Division of Reclamation,
Mining and Safety

April 15, 2016

**RE: Objections and Comments to 112c Reclamation Permit Application
Hitch Rack Ranch Quarry; DRMS File No. M-2016-010**

Figure 18 Lead Found in Water Well Test

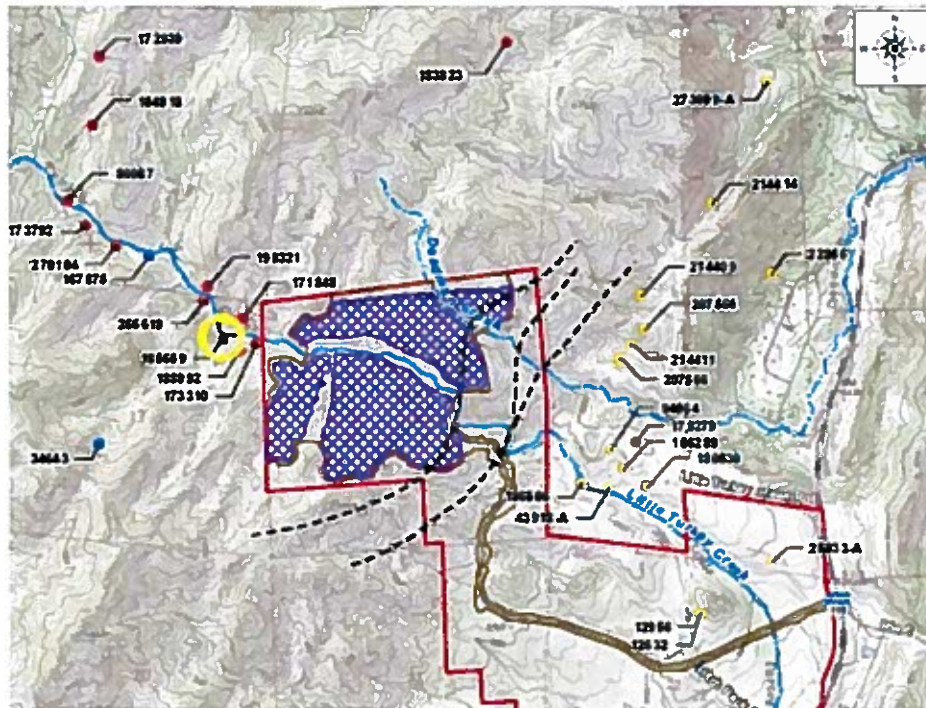
Any heavy metals uncovered by quarry operations may also contaminate wells below the quarry. For example, water tests from one of the landowner's wells located just west of the proposed quarry area identified a high level of lead. The location of this well (highlighted in yellow in Figure 18) may mean that lead deposits will be found within the North and South pits even though test bores did not indicate the presence of lead. Other heavy metals may be found as well during quarry excavations.

Figure 19 Intersection of New Quarry Road and Little Turkey Creek Road

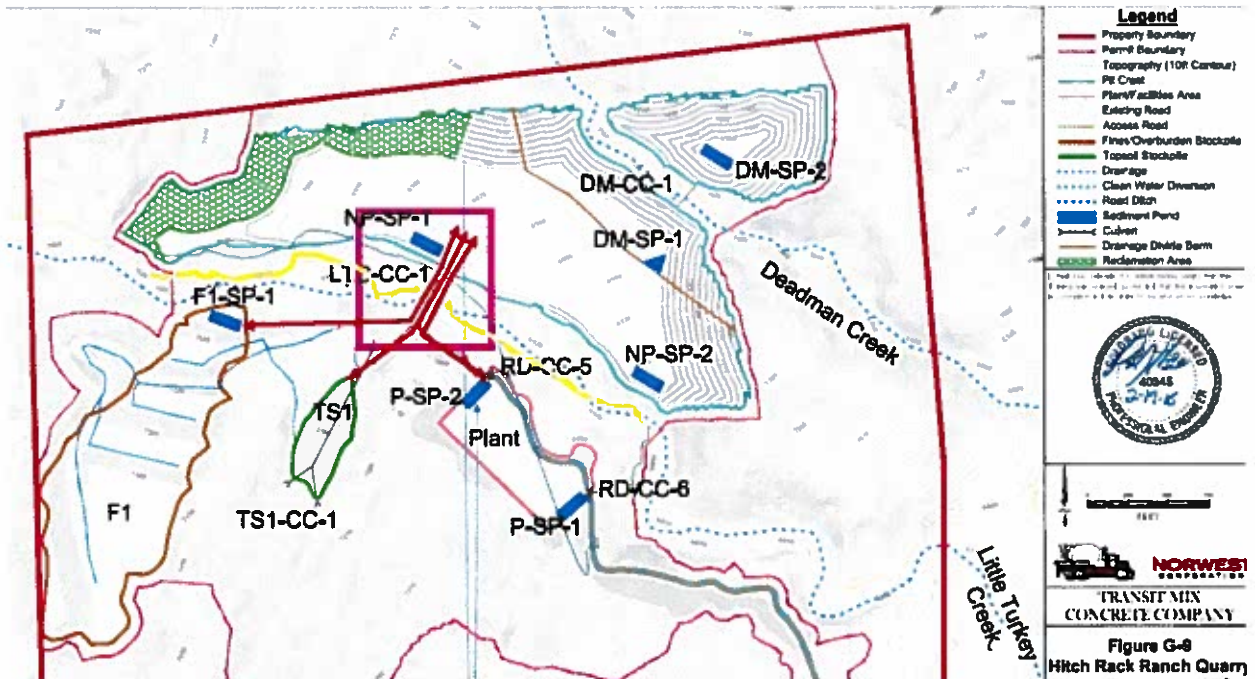
The maps provided by Transit Mix shows their new quarry road intersecting Little Turkey Creek Road in the middle of their quarry operations area within the south canyon. Little Turkey Creek Road is the yellow line in Figure 19. The intersection of the new quarry road and Little Turkey Creek road is highlighted in fuchsia.

Over the life of the quarry, millions of tons of material will be moved from the North Pit to the Top Soil Pile (TS1) during the preparation of the North Pit as well as from the North Pit to the Fines Pile (F1) while the temporary processing equipment is located within the North Pit. After the processing equipment is moved to the Plant during regular operations, raw material will be moved from the North Pit to the Plant. In order to move all of this material, large haul trucks will move through that intersection thousands of times a year during peak quarry operations. The size and frequency of haul trucks passing through that intersection may cause a significant safety issue as Eagles Nest landowners and their guests pass through that intersection to reach their properties. The intersection would be especially dangerous if there is no flagman or traffic management at that location, as is usually the case when heavy construction equipment crosses a road during highway projects.

Figure 20 Intersection of New Quarry Road and Highway 115

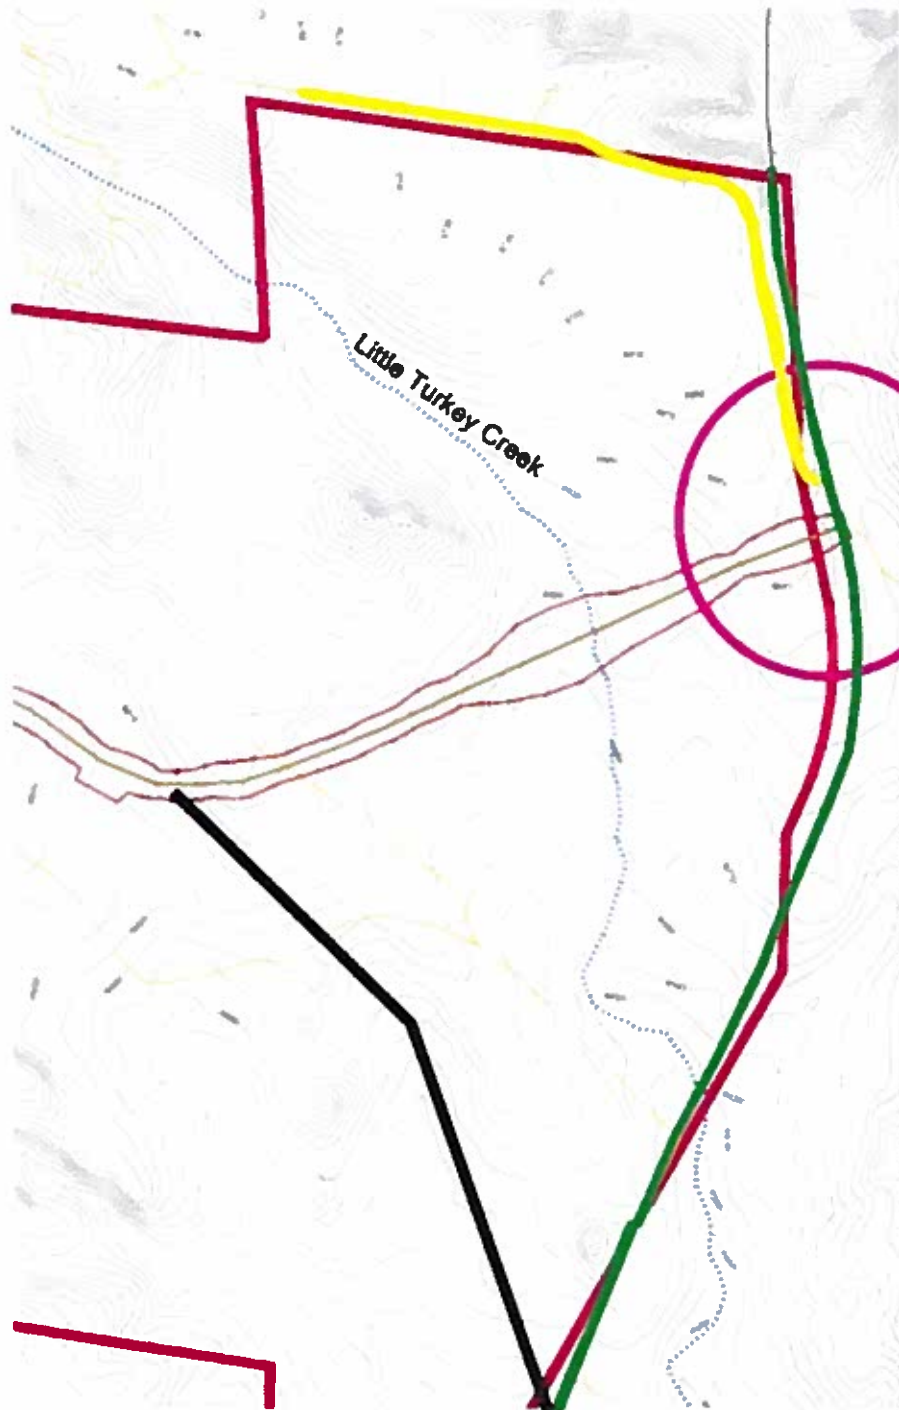
Figure 20 is a portion of the map provided by Transit Mix which shows the proposed new quarry road coming out to Highway 115 a short distance south of Little Turkey Creek Road. The

yellow line is the existing Little Turkey Creek Road. The green line is Highway 115. The fuchsia circle highlights the intersection.

Moving the new quarry road further south (as illustrated by the black line in figure 20) would eliminate the issue of the new intersection being so close to Little Turkey Creek Road intersection as well as the of line-of-sight issue with the nearby curve in Highway 115. The proposed relocation of the Highway 115 access point would also eliminate the requirement to build a stream crossing structure over Little Turkey Creek within the lower ranch.

**Figure B**  
***Transit Mix Geology Interpretation***

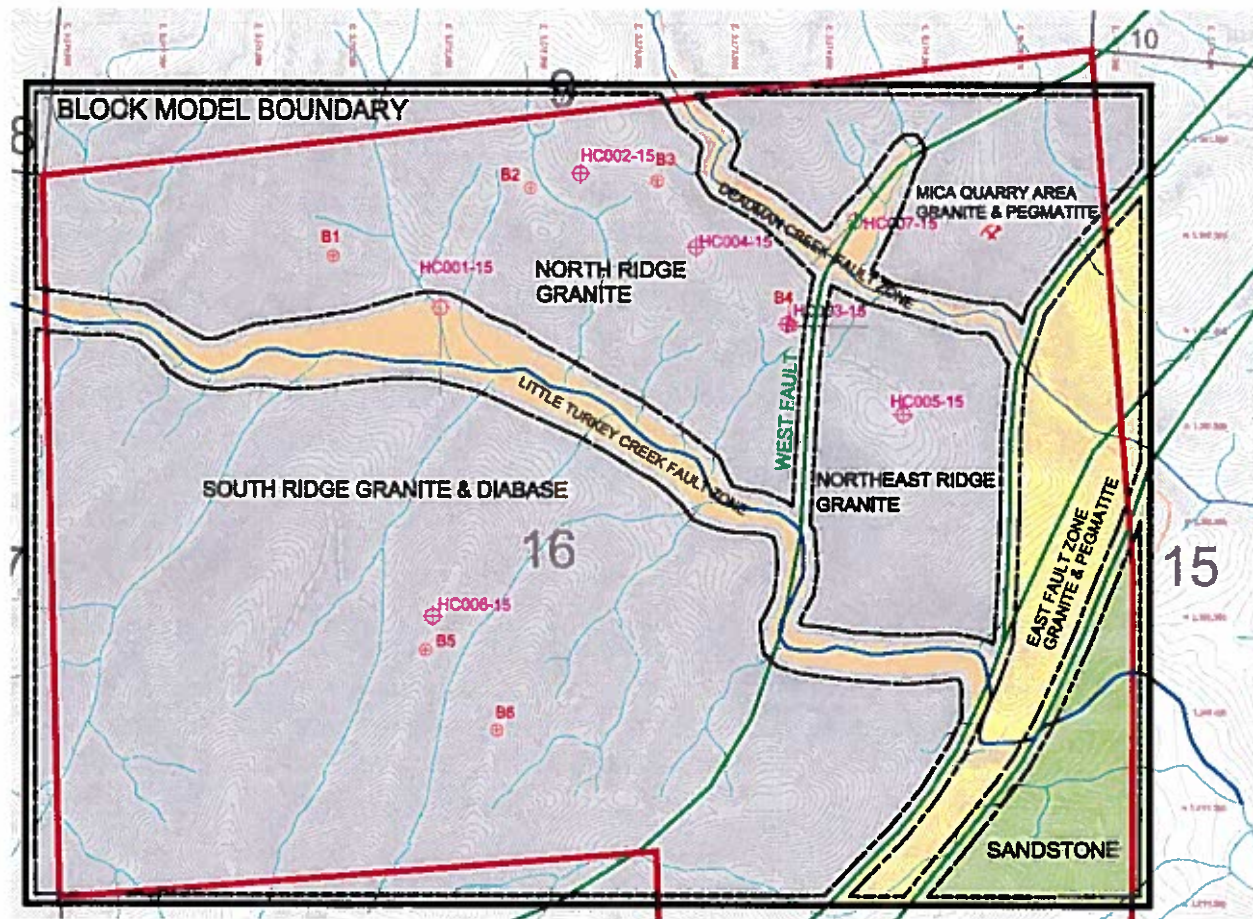
*Are they planning to use the property's ground water or not? On page G-16, it states the following, which is in direct contradiction to the above statement:*

*"Water needs for the operation include dust control on the roads and in the crushing and screening process. Water will be recycled whenever practical. The water usage plan prevents impacts to downstream water rights holders, and the sediment pond outlet works prevent impacts to water quality. The primary source of water will likely be via purchase from Colorado Springs Utilities with water hauled from Colorado Springs and stored on site. The Hitch Rack Ranch owns surface and ground water rights, and Transit Mix is evaluating the potential for future use of these waters. Transit Mix may in the future also install groundwater wells on the property to provide a supplemental water supply. Wells would be installed to prevent impacts to existing nearby water wells."*
